ARCHITECTURAL REVIEW BOARD MEETING

Thursday, May 28, 2026 at 6:30 PM

Meeting Date:	May 28, 2026
Agenda Title:	COA 26-11 82 Main Street
Requested Action:	Review for alterations to the building's 4 th Street elevation: proposed hanging sign and an A-frame sidewalk sign
Department / Agency Lead:	Community Development
Staff Lead:	Whitney Burgess, Preservation Planner

Meeting Date:	May 28, 2026
Agenda Title:	Work Session: 22 Waterloo Street
Requested Action:	Work session review of proposed rear addition, façade improvements, and hardscape alterations at Red Truck Bakery
Department / Agency Lead:	Community Development
Staff Lead:	Whitney Burgess

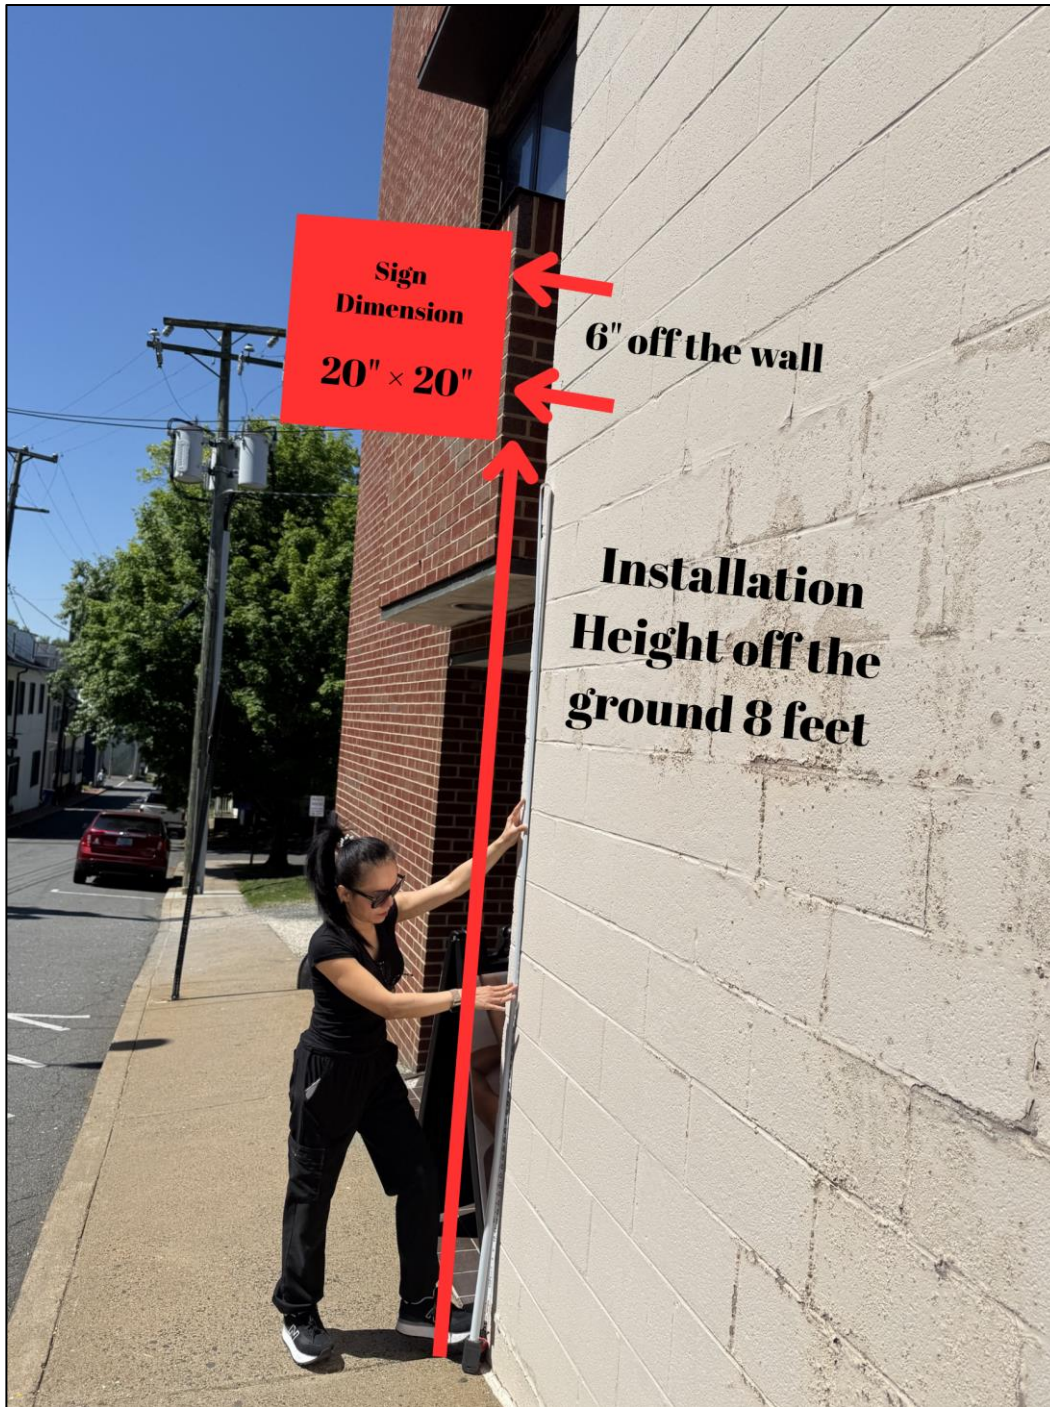
- The proposed sign measures 20" x 20" x 4"
- Installation will be 8 feet above the sidewalk and extend 6 inches from the building façade, which meets the requirements for hanging signs per article 4.F of the Historic District Guidelines;
- Meets the requirements of one projecting sign allowed per business.

- The proposed sidewalk sign measures 24" x 36" inches
- The proposed sign will be placed under the drip line of the entry opening to allow 4 feet of accessible sidewalk, per article 6-15.6 of the Zoning Ordinance

- 1) All necessary permits are acquired;
- 2) The hanging sign shall not exceed 30" x 30";
- 3) The bracket shall be installed only within the mortar joints and not directly into the brick to avoid damage to the masonry;
- 4) The hanging sign shall have at least 4 inches of clearance from the end of the sign to the face of the wall;
- 5) The bottom of the hanging sign to the sidewalk must provide at least 8 feet of clearance;
- 6) The A-Frame sign shall be internally weighted (can use sandbags, weights, etc.);
- 7) The A-Frame sign shall leave at least 4 feet of clearance along the sidewalk, so it does not impede any pedestrian traffic.

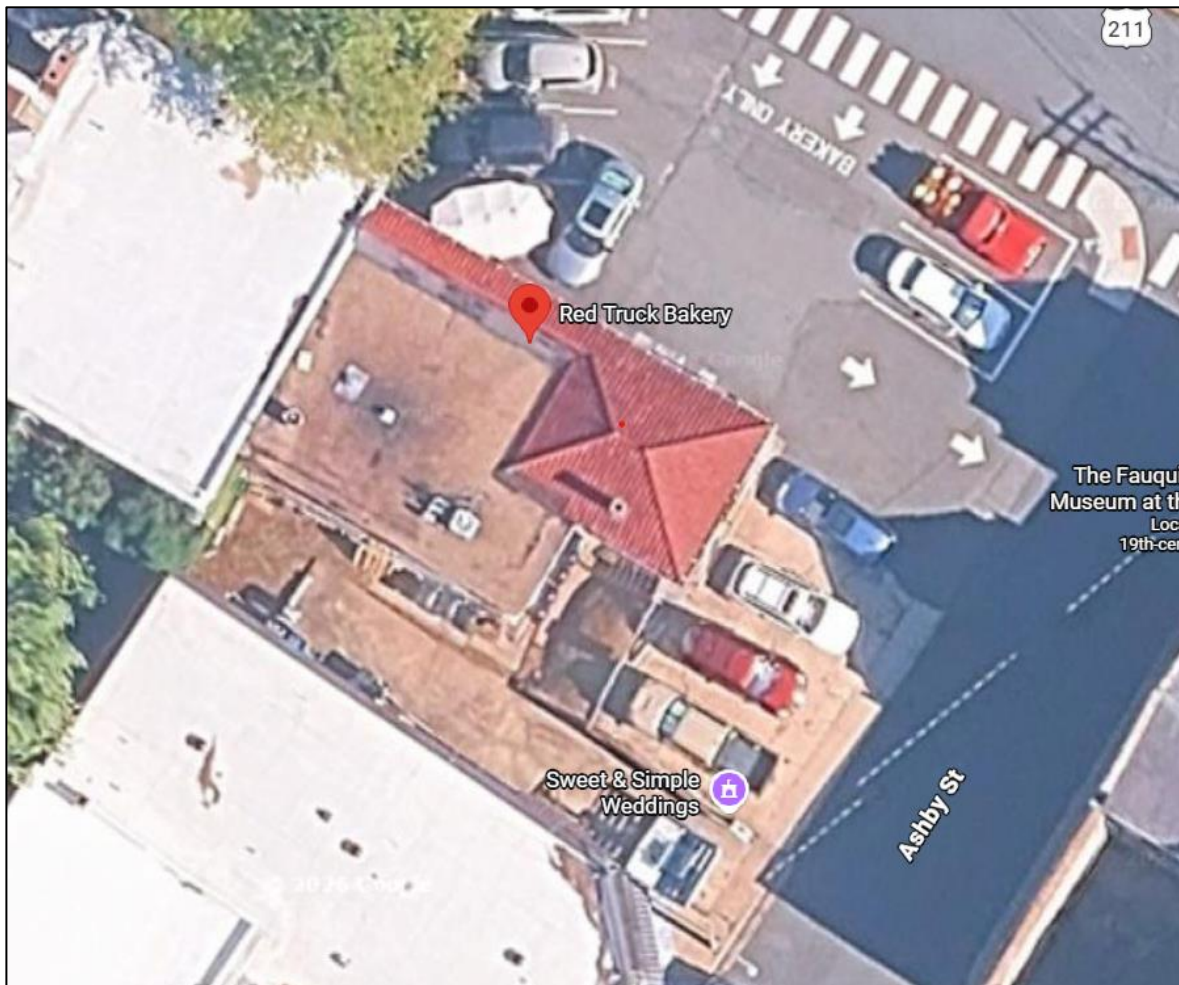
3. Parking – The proposed work must accommodate at least one handicapped parking space on the lot and provide an accessible pathway/entry to the building. The applicant should revise the plan prior to ARB approval.

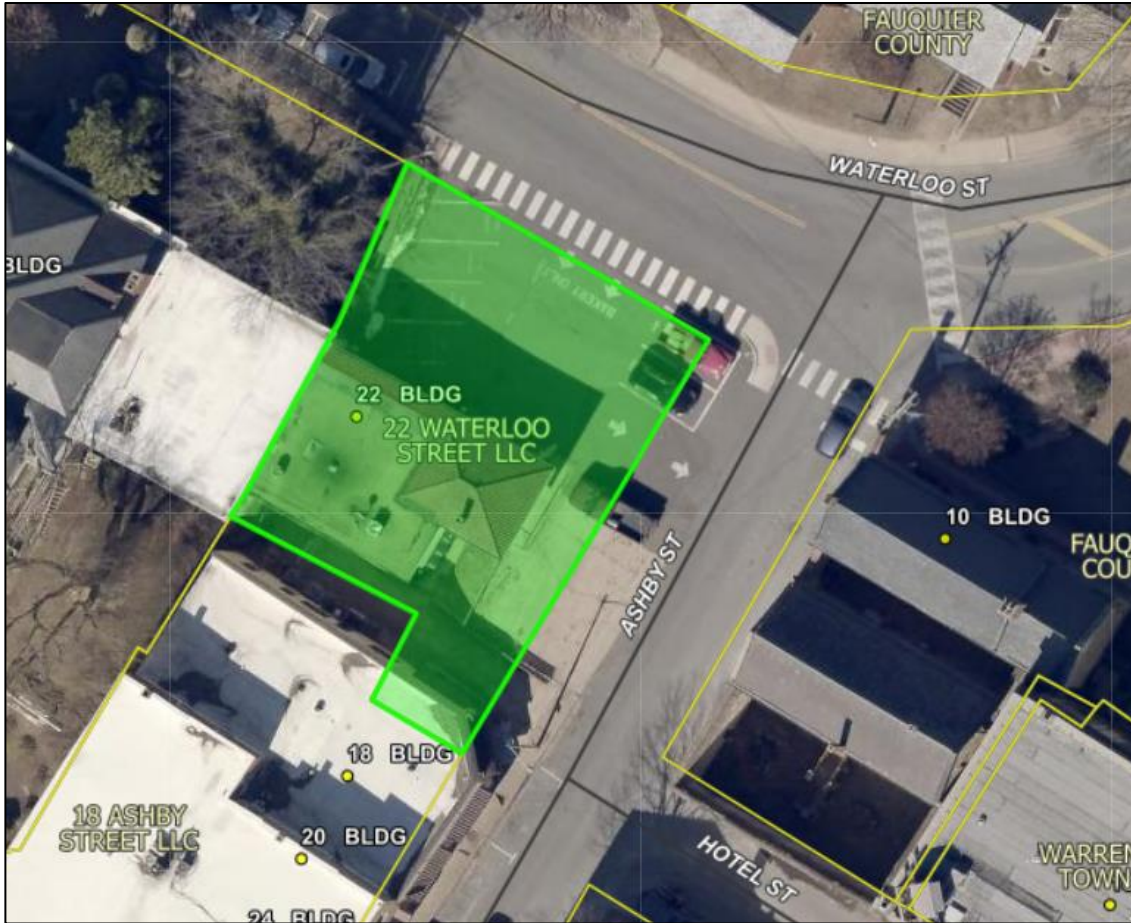
The application needs to demonstrate adequate parking to meet Article 7 – with the expanded seating areas, this appears to be a Restaurant, Fast Food use. The minimum required number of on-site parking spaces is 1 parking space per 150 square feet of gross floor area. In the CBD district, there are specific parking reductions that they may qualify for, as listed in Section 7-9 and 7-13 of the Zoning Ordinance. The applicant must demonstrate that they qualify for these parking reductions. I strongly recommend that they demonstrate their compliance with the parking requirements prior to any approval by the ARB.

Minimum parking space size requirements and minimum drive aisle widths must be met, as found in Section 7-17 of the Zoning Ordinance. As a recommendation, this should be demonstrated prior to ARB approval.
